QUESTION 110.1

SSES-FSAR

**SUSQUEHANNA STEAM ELECTRIC STATION
UNITS 1 AND 2
FINAL SAFETY ANALYSIS REPORT**

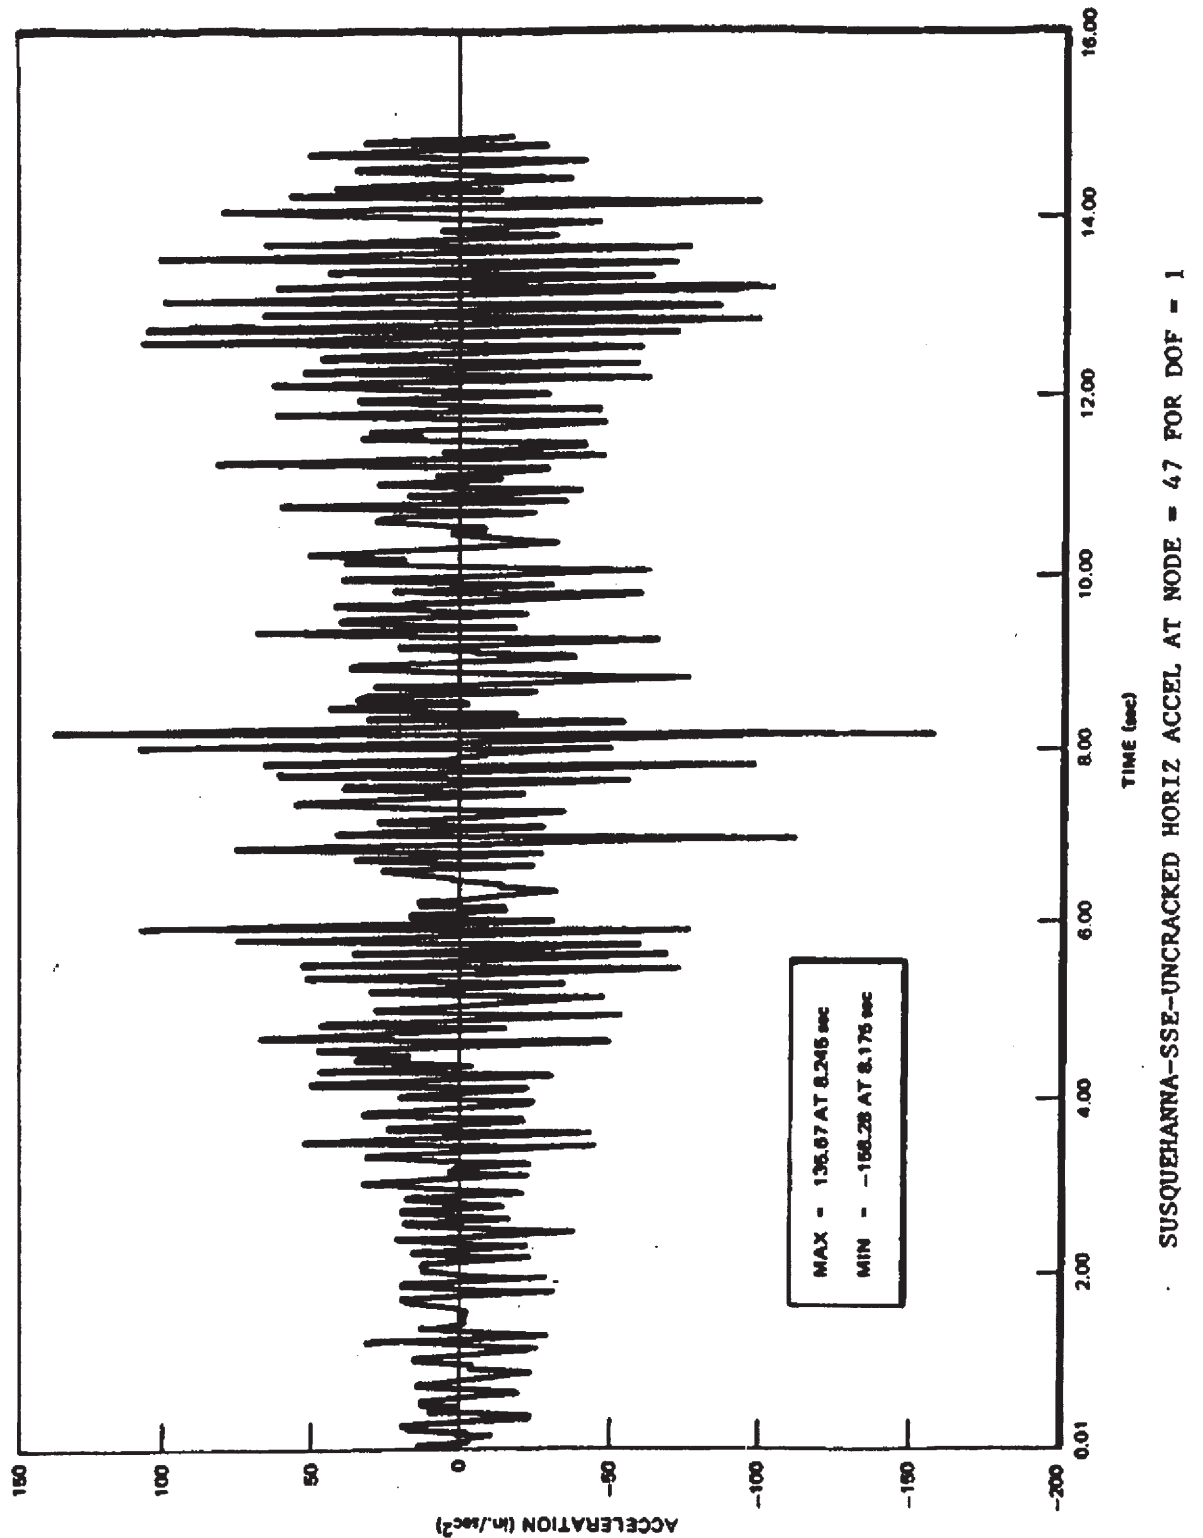
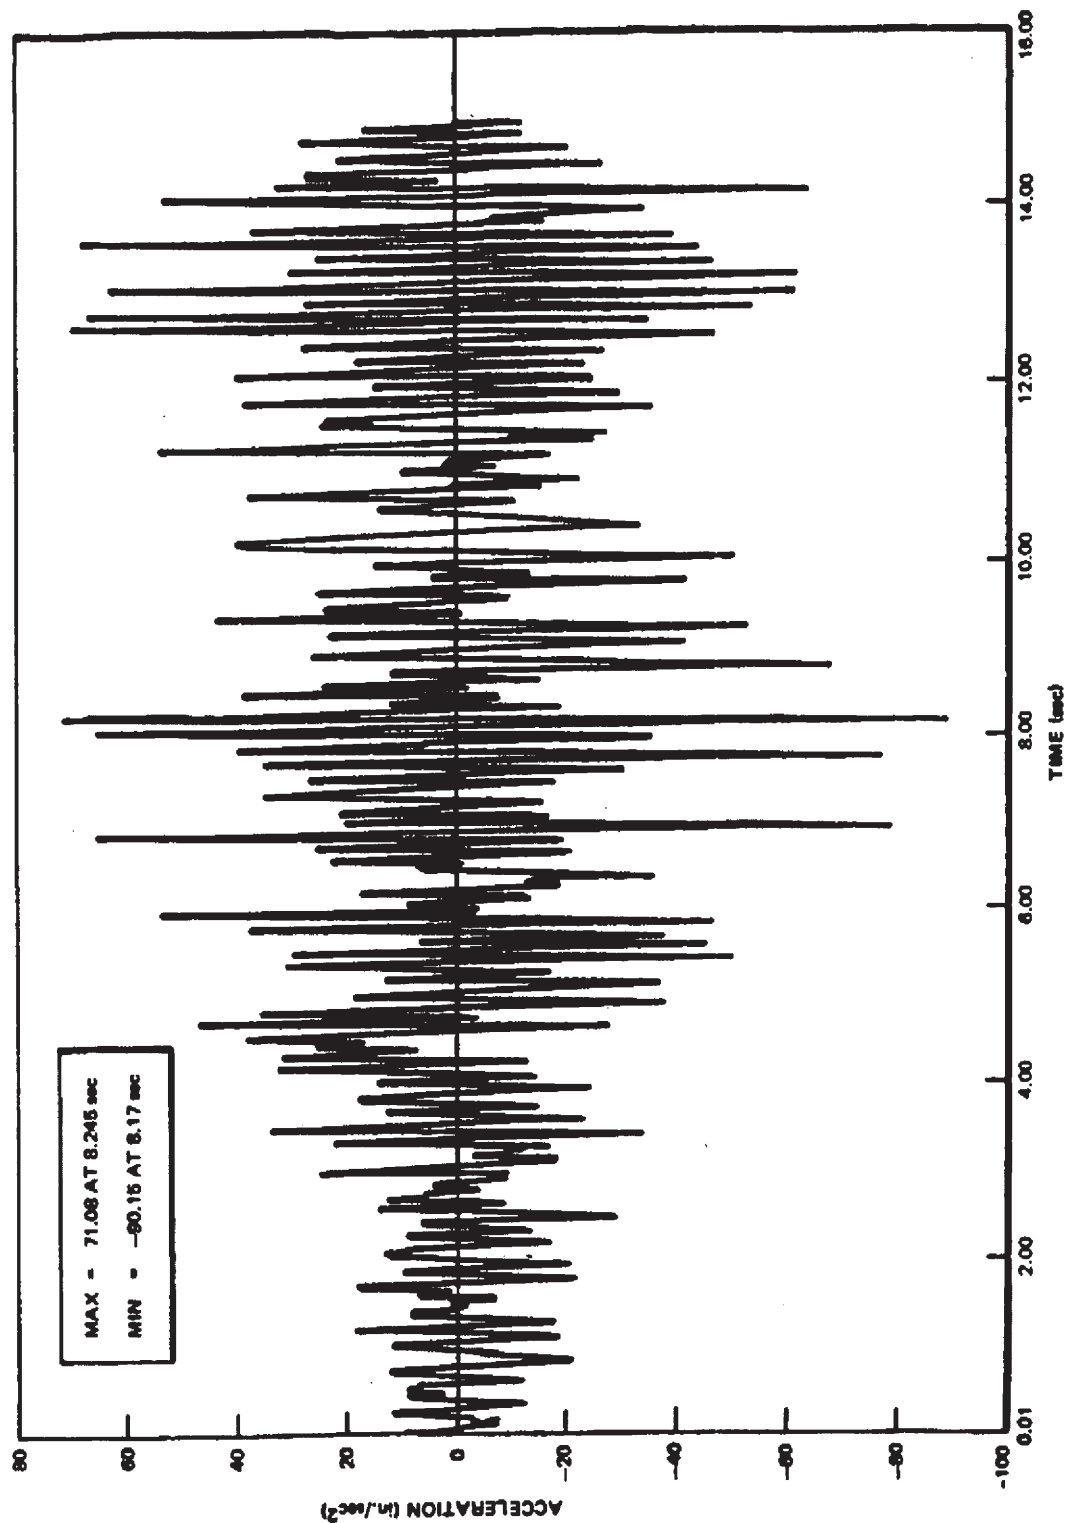
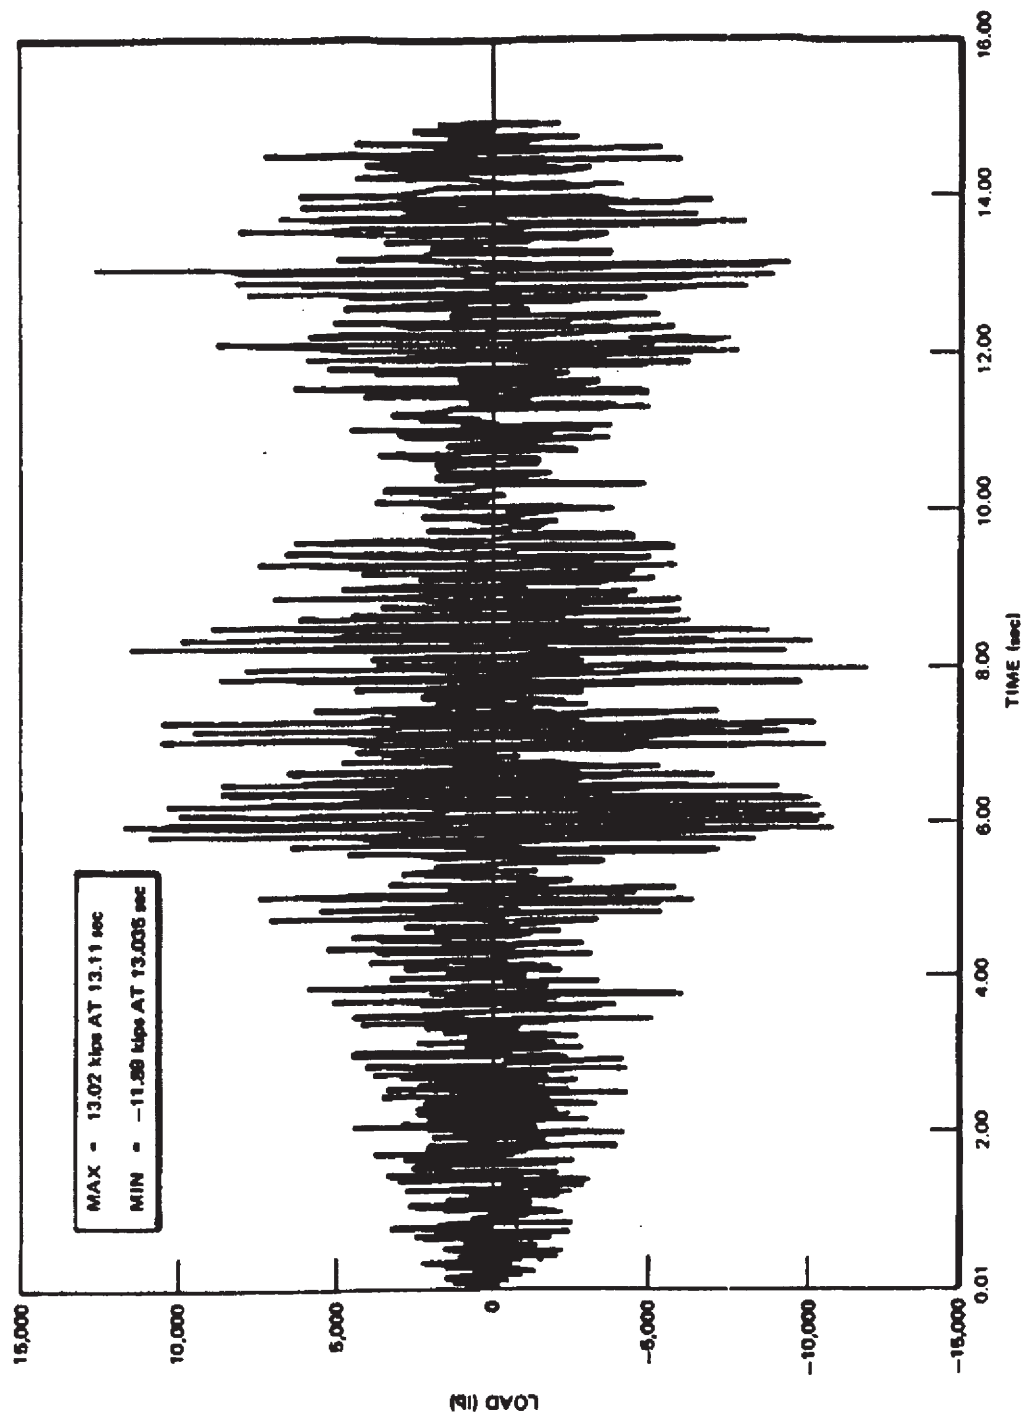
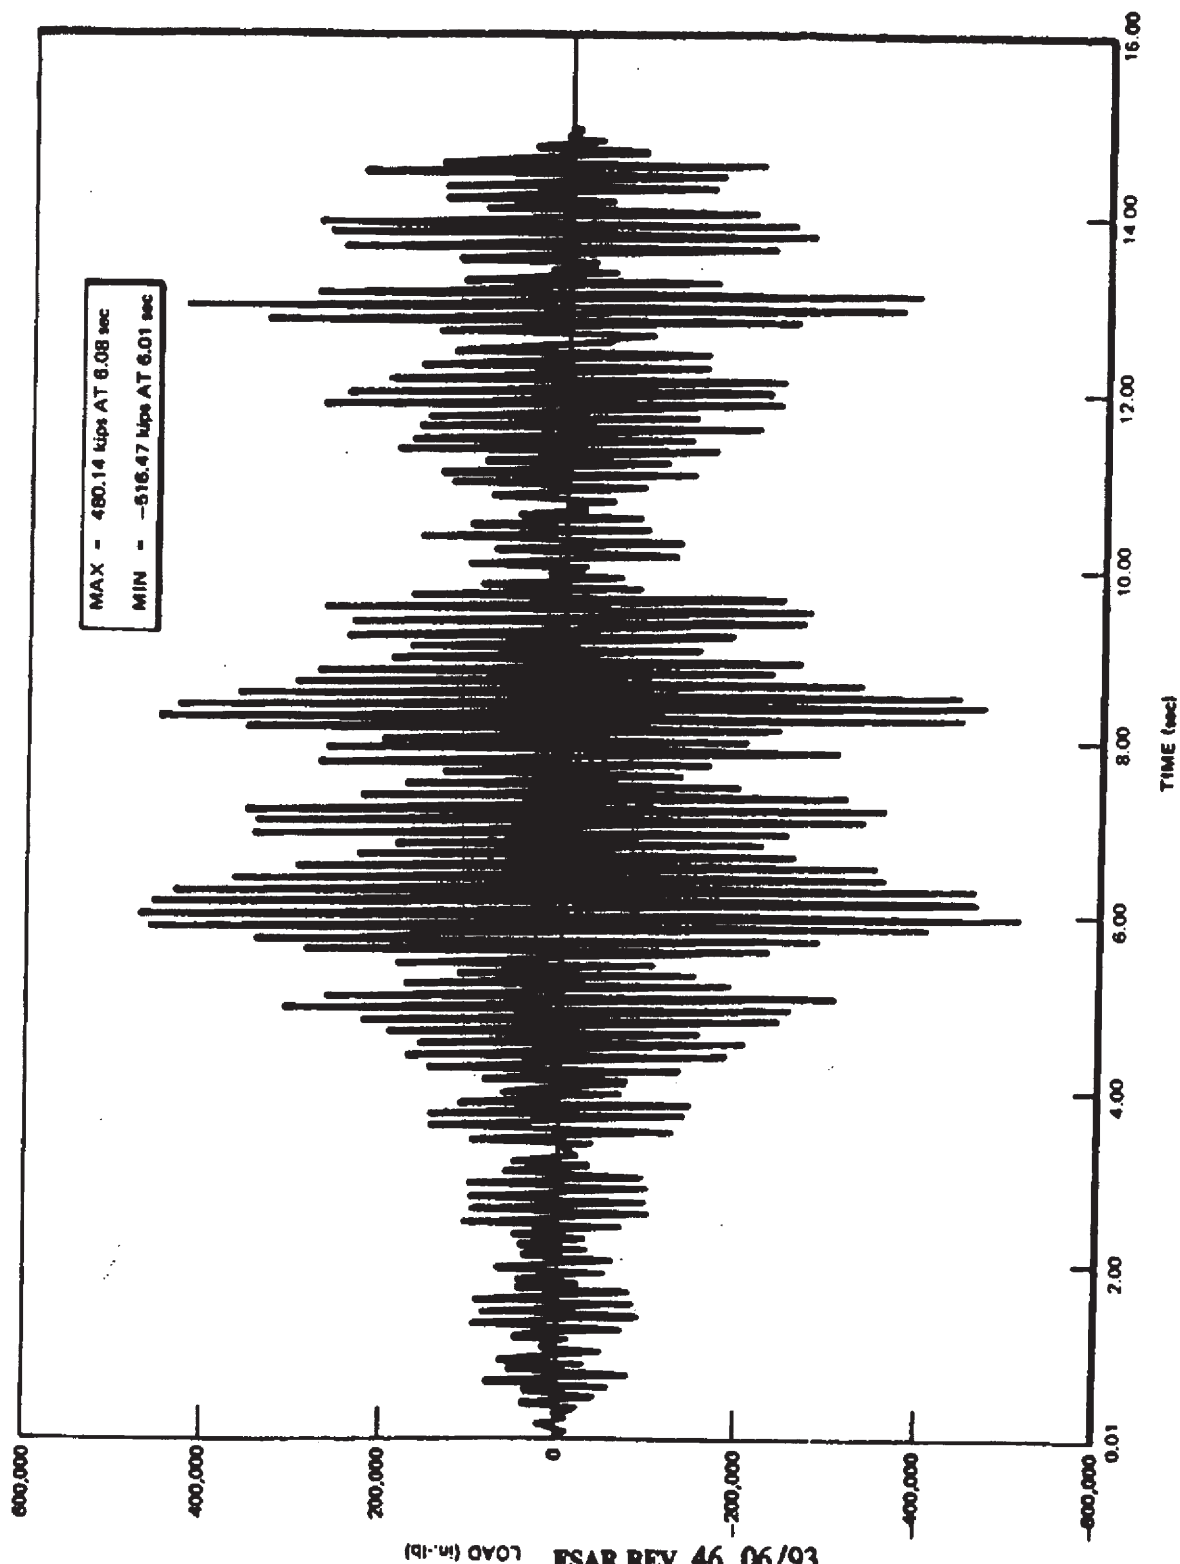
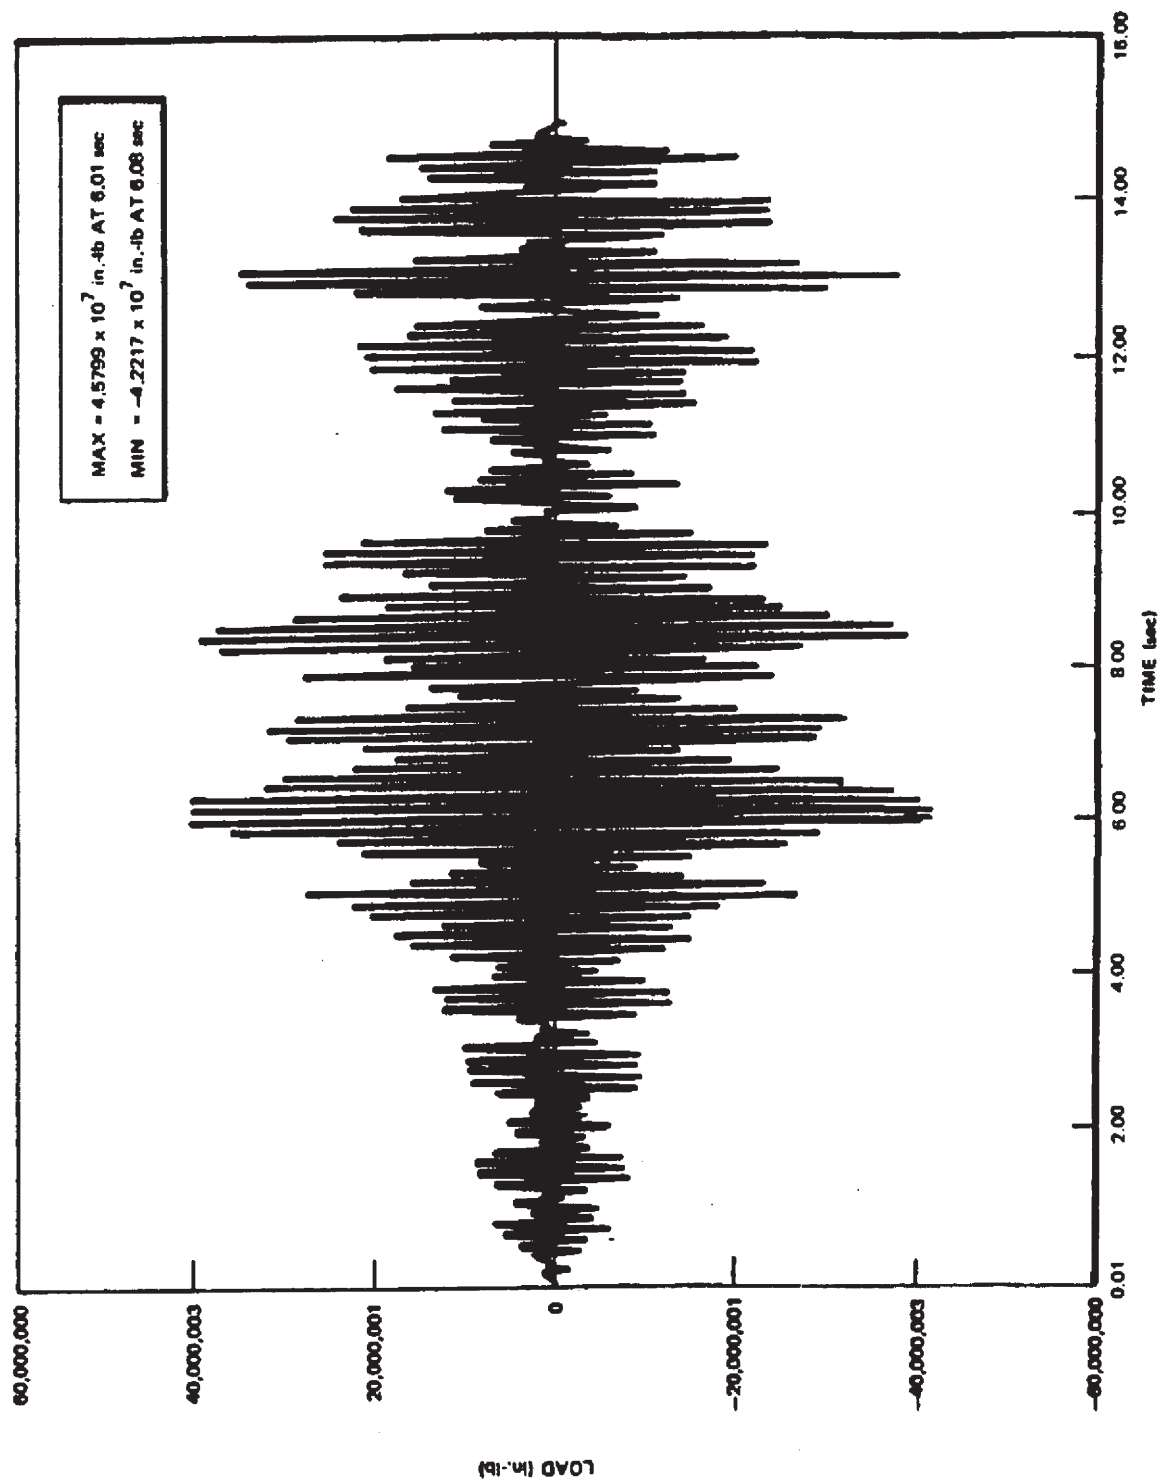
- a) Provide response time histories at one key location (having either the maximum stress combination or the most critical deflection combination, whichever is governing the design) for each of the following internal components:
 - (1) Jet pump
 - (2) Shroud wall
 - (3) Shroud head
 - (4) Control rod
 - (5) Instrumentation guide tube
 - (6) Core plate

For each location, separate response time histories for the various load effects associated with the SSE and most severe pipe break event should be provided.

- a) The following additional response time information for selected internal components under the SSE and the most severe pipe break accidents is provided.

Figures 110.41-3 thru 110.41-10 - Response time history plots due to horizontal SSE.

Figures 110.41-11 thru 110.11-16 - Response time history plots due to vertical SSE.

Figures 110.41-17 thru 110.41-24 - Response time history plots due to recirculation pipe break.

Figures 110.41-25 thru 110.41-32 - Response time history plots due to feedwater pipe break.

As for the pipe break events, we have considered both the feedwater line break and the recirculation line break. Judging from the response time histories, it is not conclusive as to which one is governing. Hence, we have included both sets.
